Re: WBI Energy Transmission, Inc.  
Wahpeton Expansion Project  
Docket No. CP22-466-000  
Variance Request for Project Modifications

**Wahpeton Expansion Project  
Summary of the Proposed Project Modifications**

**V5 and V42**

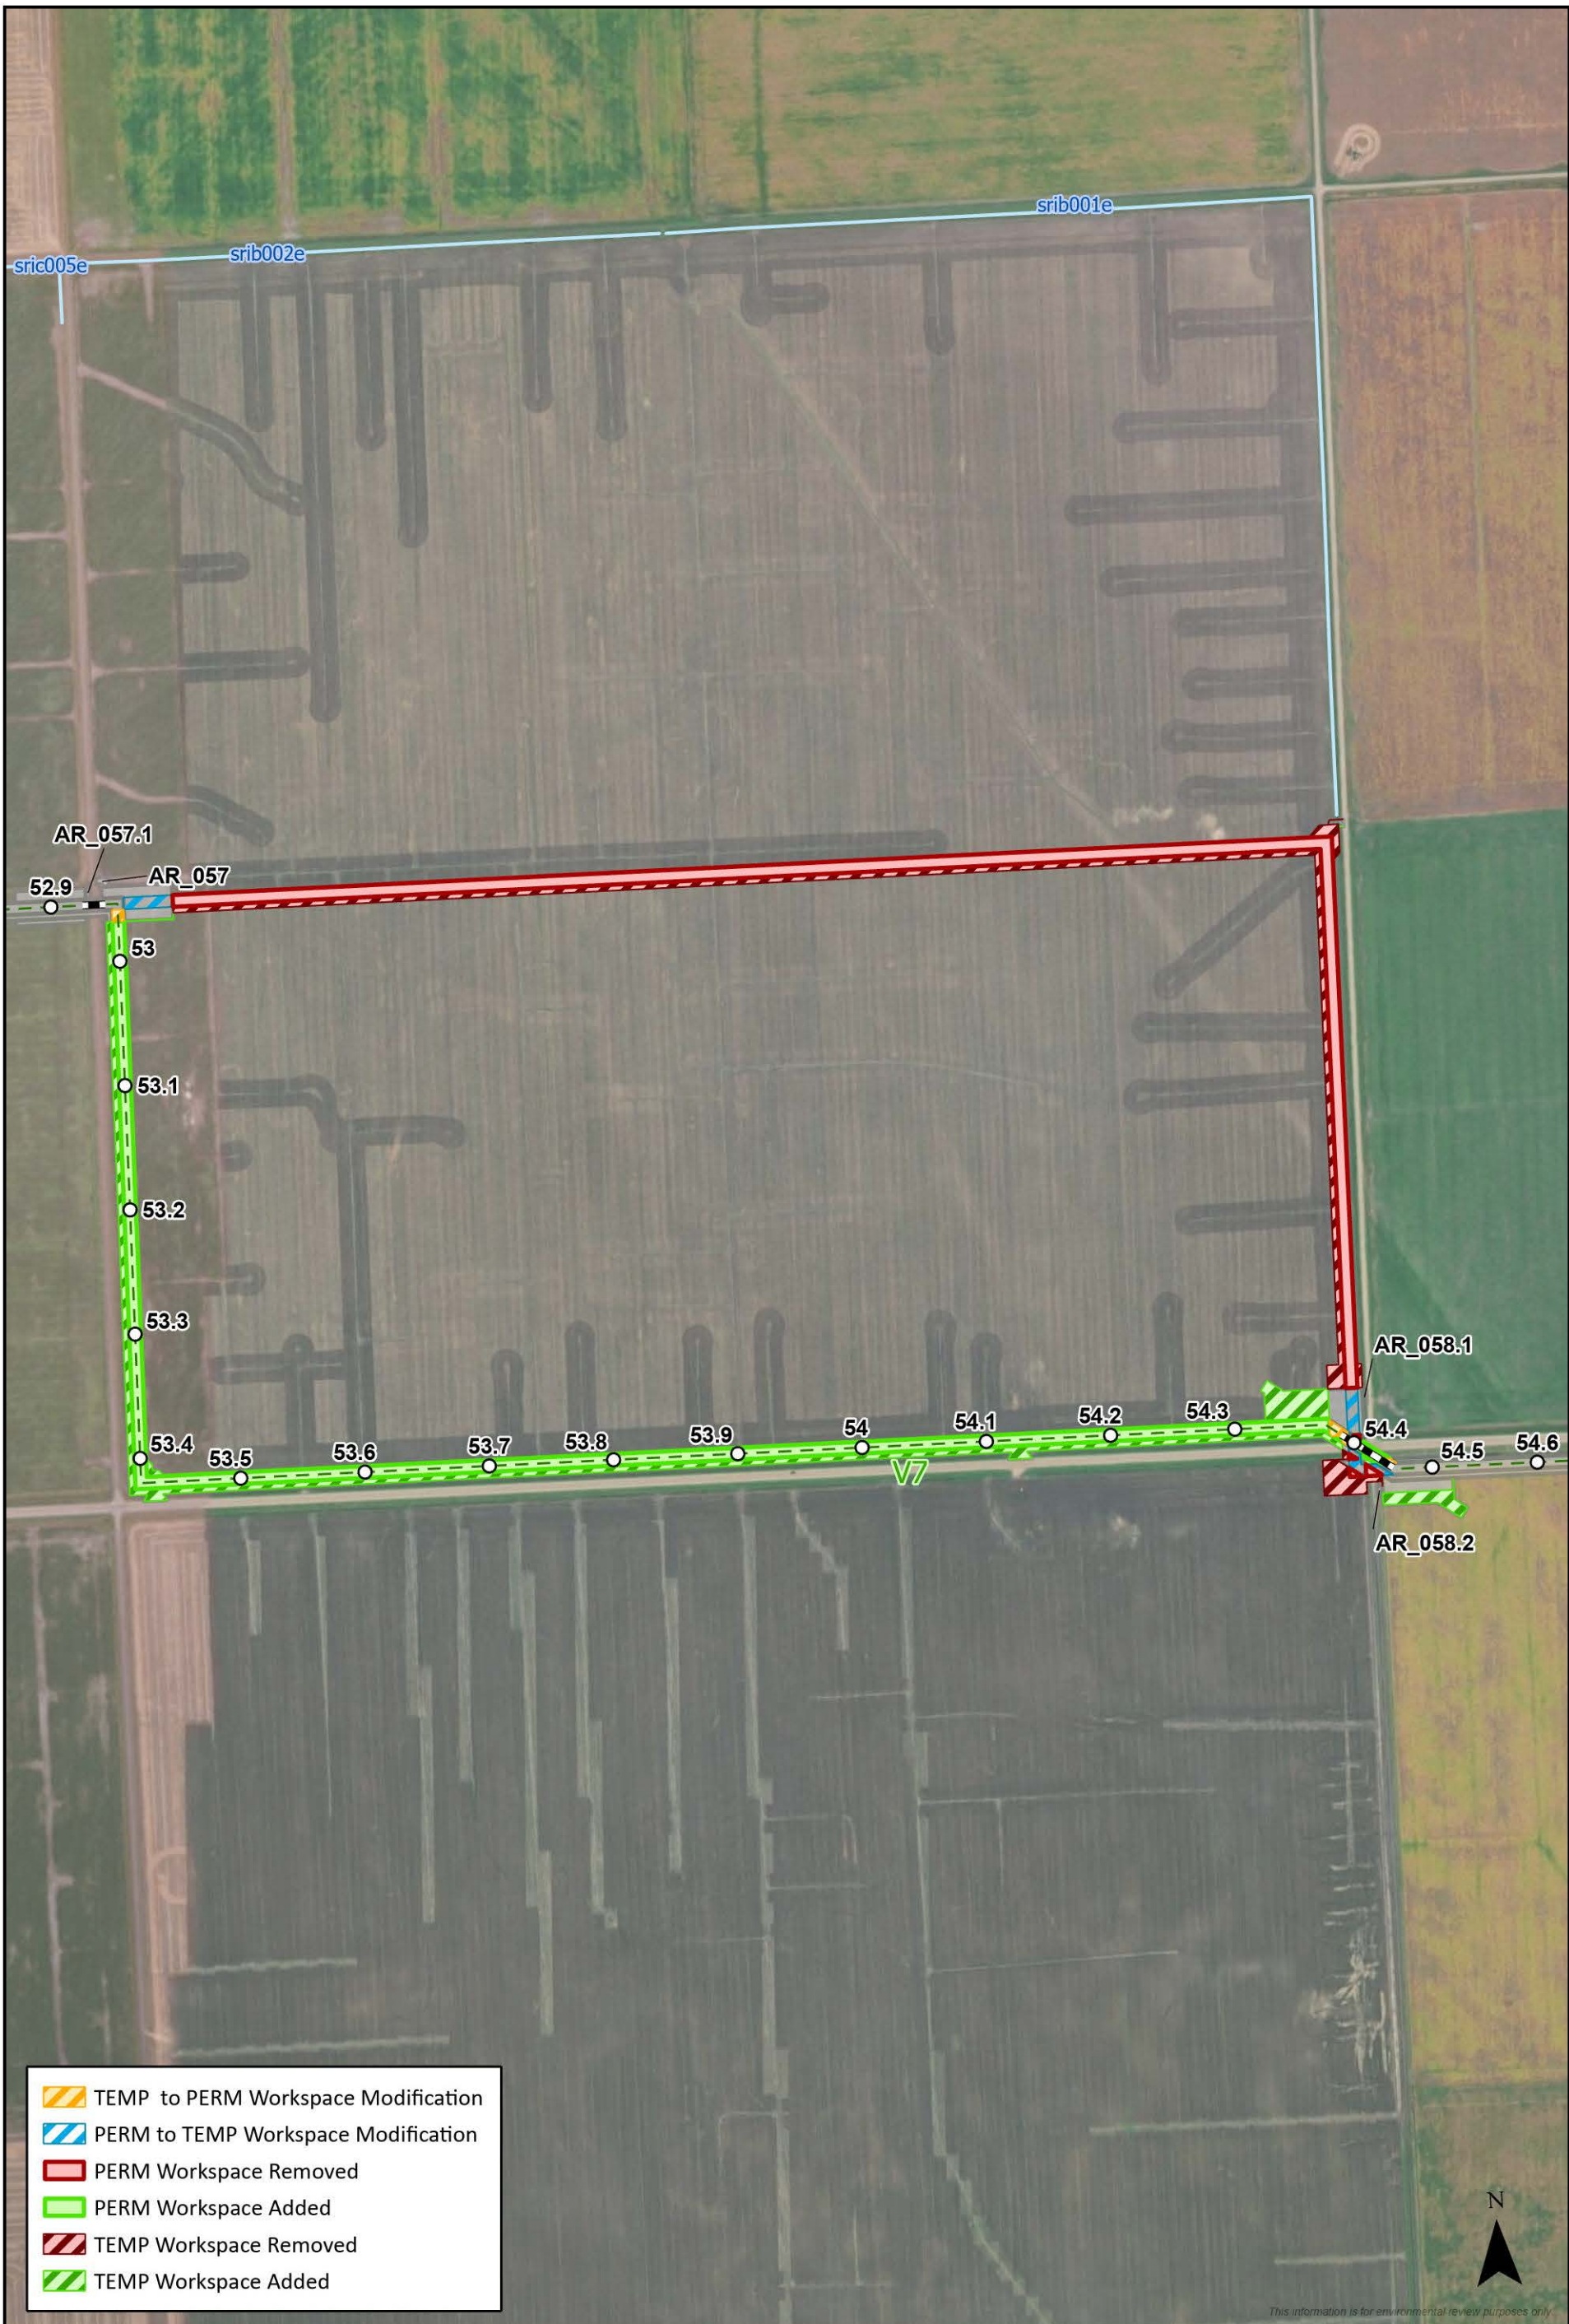
- Additional temporary workspace for a guided bore road crossing (V05);
- Five landowner-requested minor reroutes (V7, V12, V57, V59, V61);
- Landowner requested relocation of the MDU-Wahpeton Border Station (V14);
- Utilize 10 existing approaches as temporary access roads (V15, V31, V34, V40, V41, V42, V43, V44, V45, V51);
- The modification of three approved access roads for safety reasons (V32, V60, V66); and
- Minor shift of the footprint of a valve site to align aboveground facilities with the pipeline alignment (V60).

**V31**

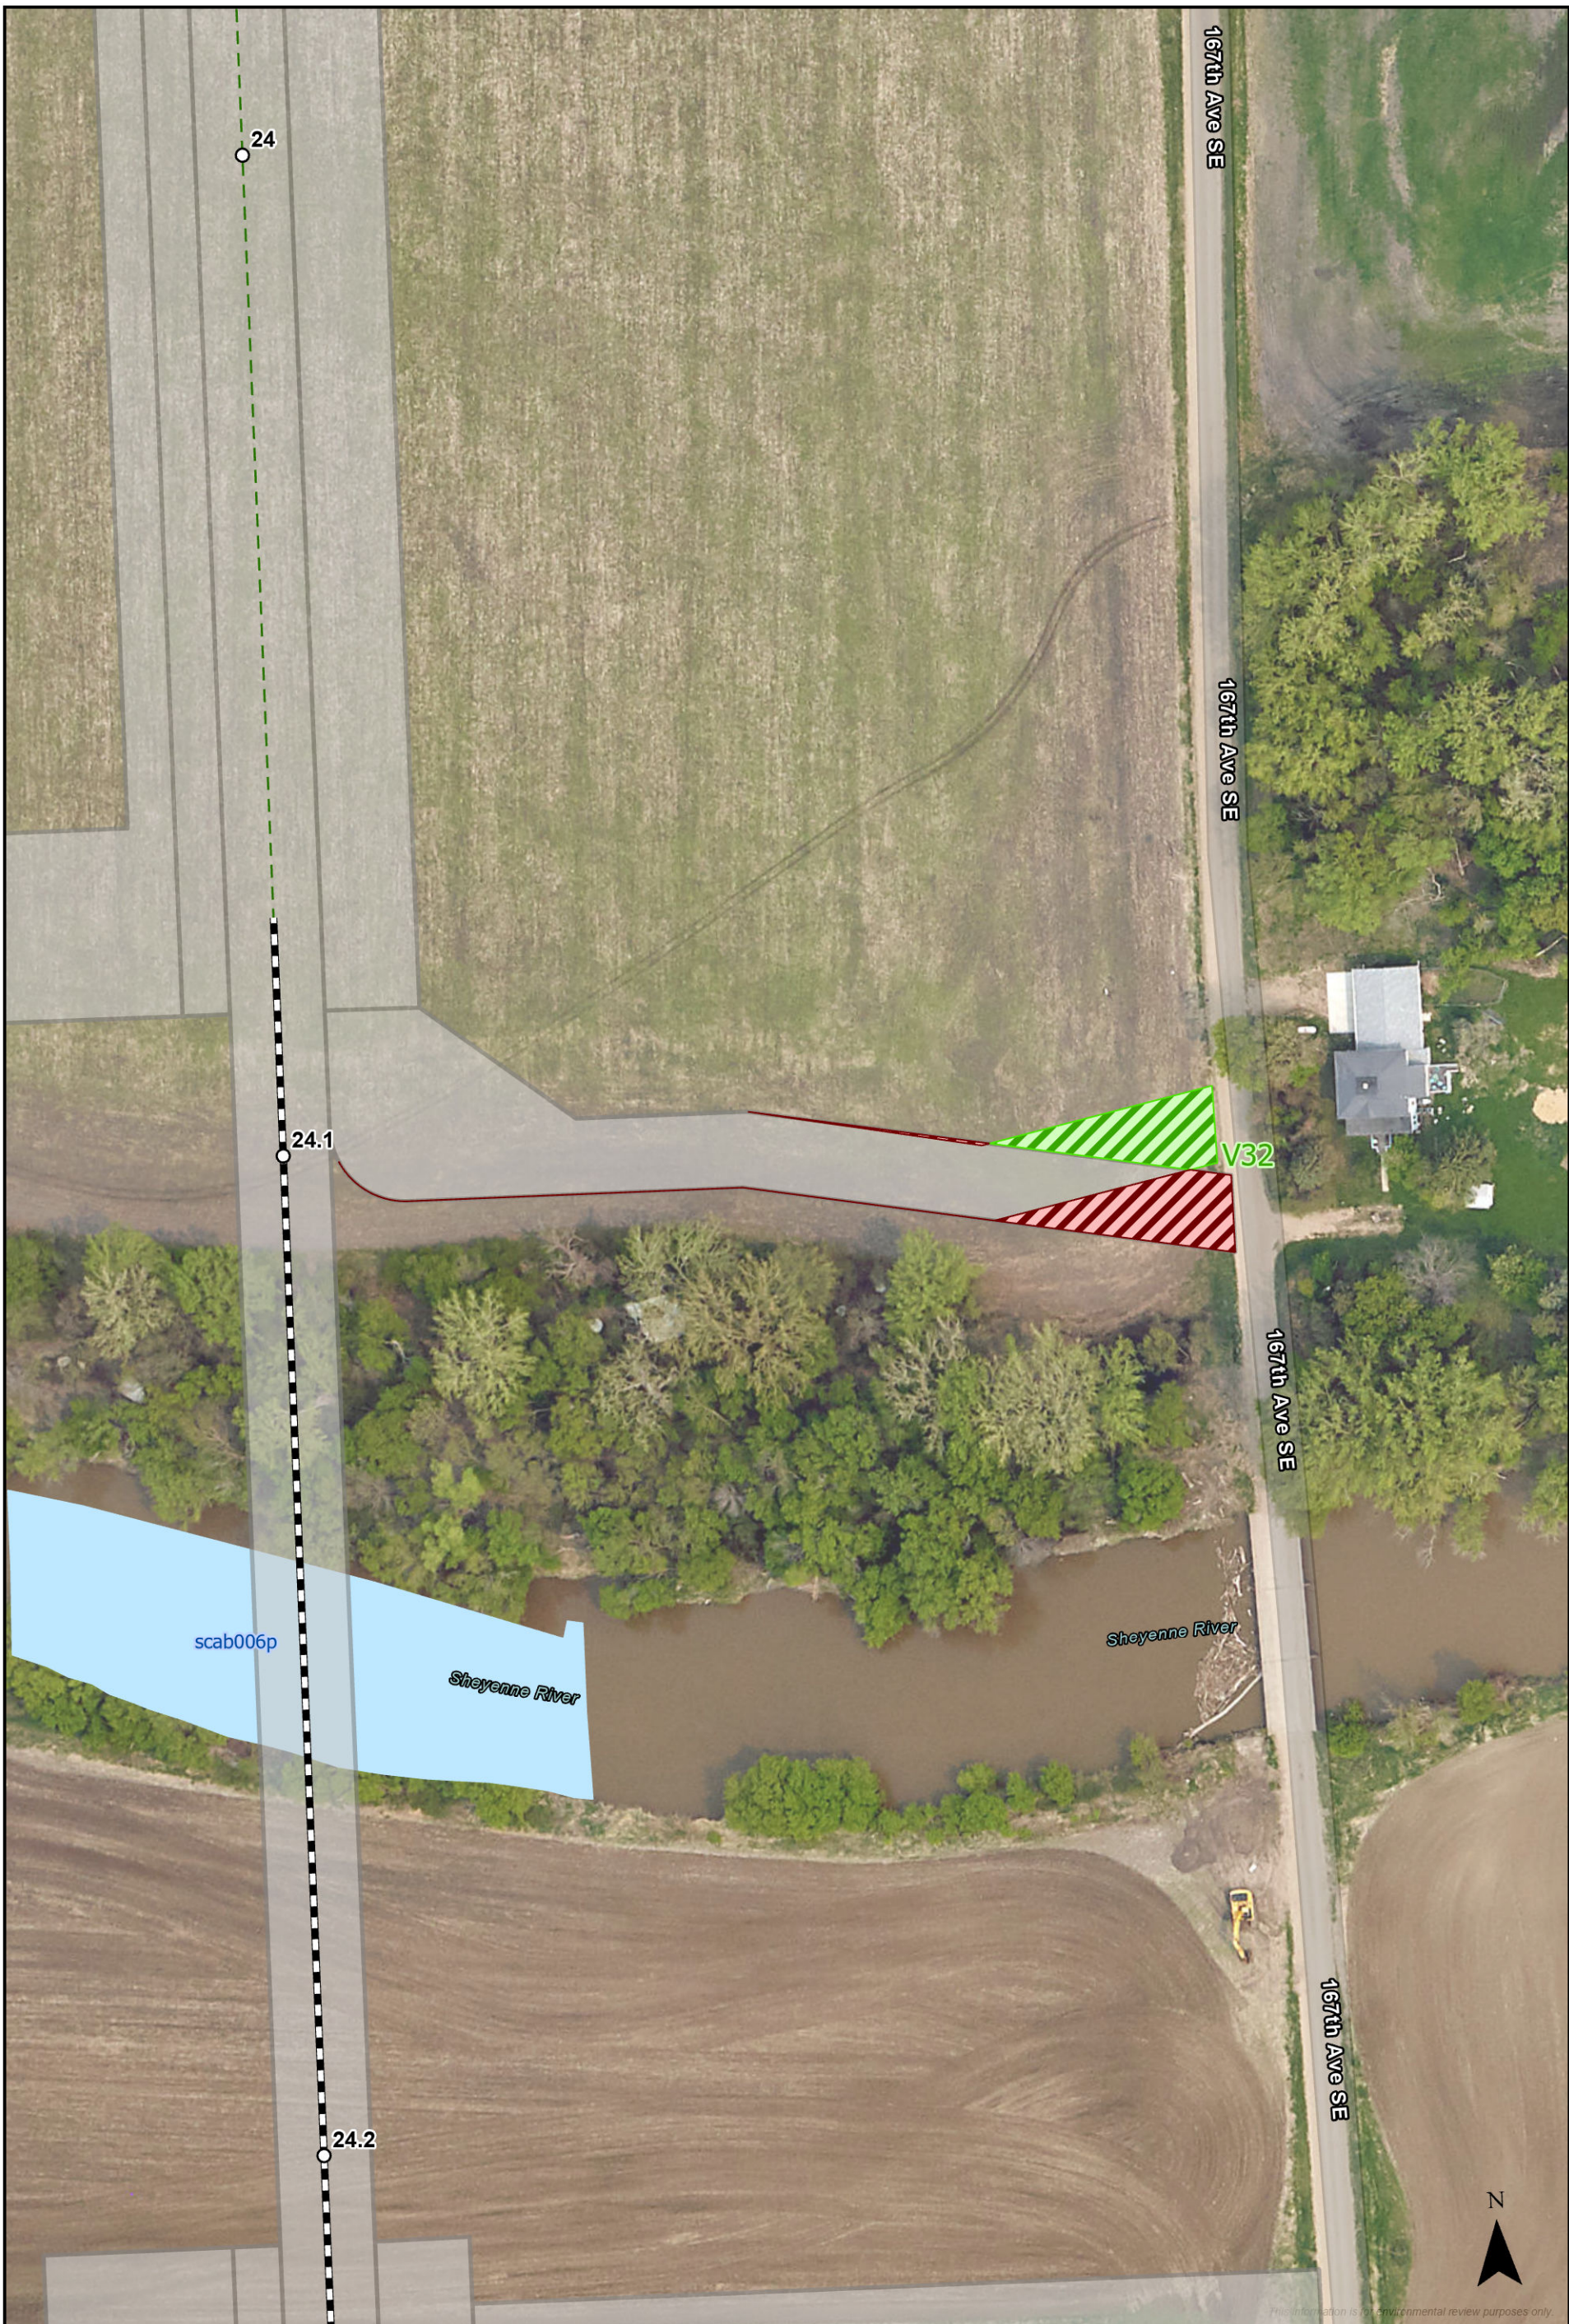
V31	New Temporary AR-025.1	Cass	23.3 - 23.6	11 / 1230+00 to 1240+00	To access the construction ROW, WBI Energy will utilize an existing approach and travel through an agricultural field north of 53rd St. SE from MP 23.6 to MP 23.3 to avoid a deep drainage ditch off of 53rd St. SE onto the construction ROW. Waterbody scae003e runs through an existing 36-inch culvert at the existing approach.	2.24	0	Yes 3/	Yes	Yes 6/	Agricultural /Developed	Yes 3/01/2024
V32	Modify AR-027	Cass	24.1	12 / 1270+00	Modify an approved temporary access road west of 167th Ave. SE and east of MP 24.1 by shifting temporary workspace north to avoid a severe approach drop-off from 167th Ave. SE. 10/	-0.01	0	Yes 3/	Yes	Yes 6/	Agricultural /Developed	Yes 3/01/2024
V34	New Temporary AR-028a.2	Cass	24.7	12 / 1306+21	To access the construction ROW, WBI Energy will utilize an existing approach and travel through an agricultural field west of 167th Ave. SE and south of MP 24.6 to provide safe access to the construction ROW and minimize construction equipment crossing 54th St. SE (Highway 46).	0.28	0	Yes 3/	Yes	Yes 6/	Agricultural /Developed	Yes 3/15/2024
